FIELD SERVICE CAMPAIGN BULLETIN

Subject: **Field Service Campaign D19M1**
GHG17 Detroit™ DD16® Software Reprogramming

Figure 1 – DiagnosticLink® Identification Screen

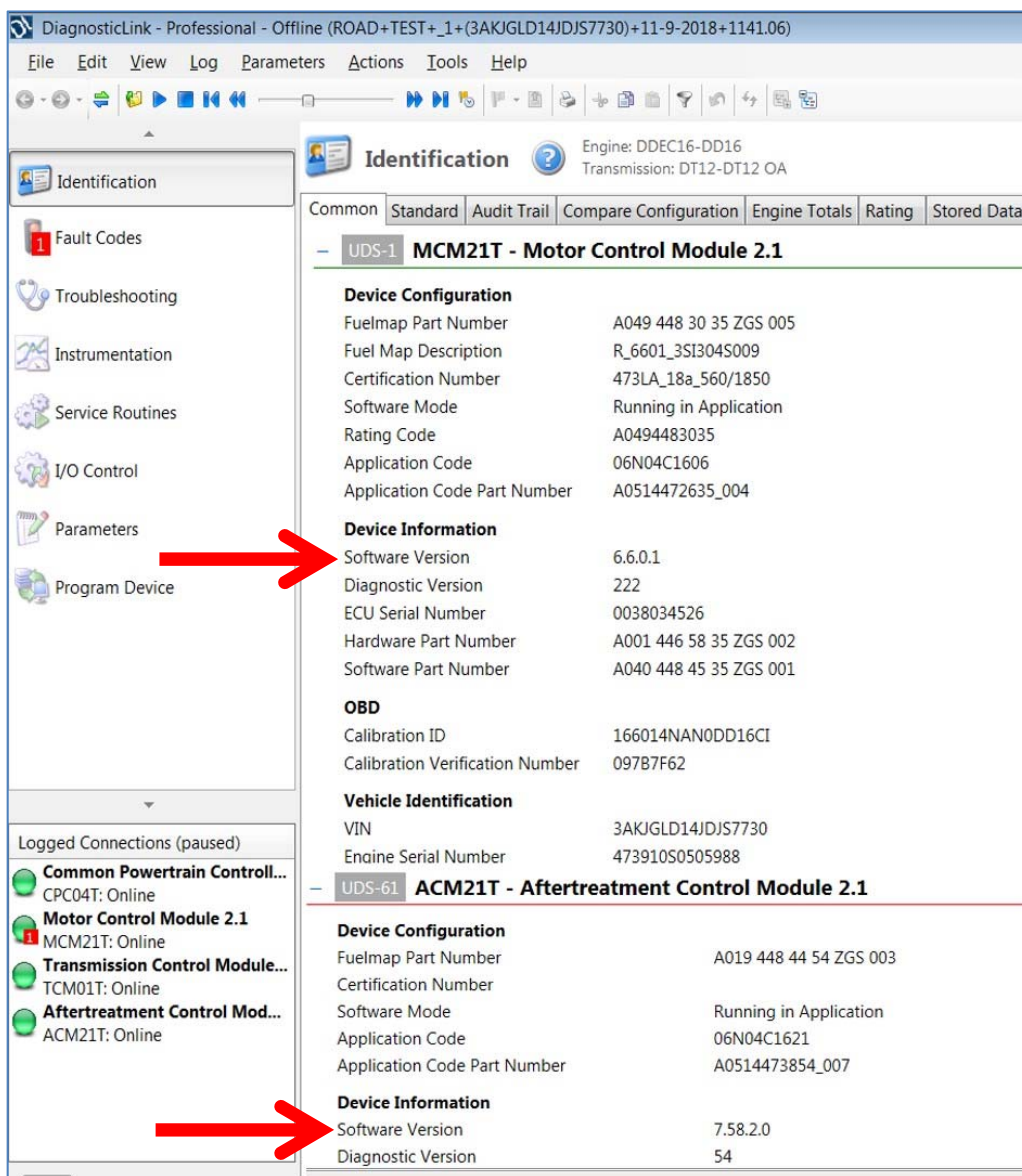
5. On the Identification screen, check the current MCM, ACM, CPC, and if applicable the TCM, software. Listed below are the **MINIMUM** levels required. See Figure 1 for an example of the Identification screen.
 - a. MCM software **6.7.0.2**
 - b. ACM software **7.59.2.0**
 - c. For non-New Cascadia vehicles, CPC software **R42 00 000A**
 - d. For New Cascadia vehicles, CPC software **31.23.00**
 - e. For DT12 equipped vehicles, TCM software **NAMT150700**

6. Is the **software** level for all modules less than, equal to, or higher than the software levels listed in step 5? For example in Figure 1, MCM software 6.6.0.1 and ACM software 7.58.2.0 are both less than 6.7.0.2 and 7.59.2.0, and thus would require programming.
 - a. If less than the required software levels, proceed to step 7.
 - b. If equal to or higher than the required software levels, no programming is necessary. Proceed to step 13.
7. Select the “Program Device” option along the left side of the DiagnosticLink® screen.
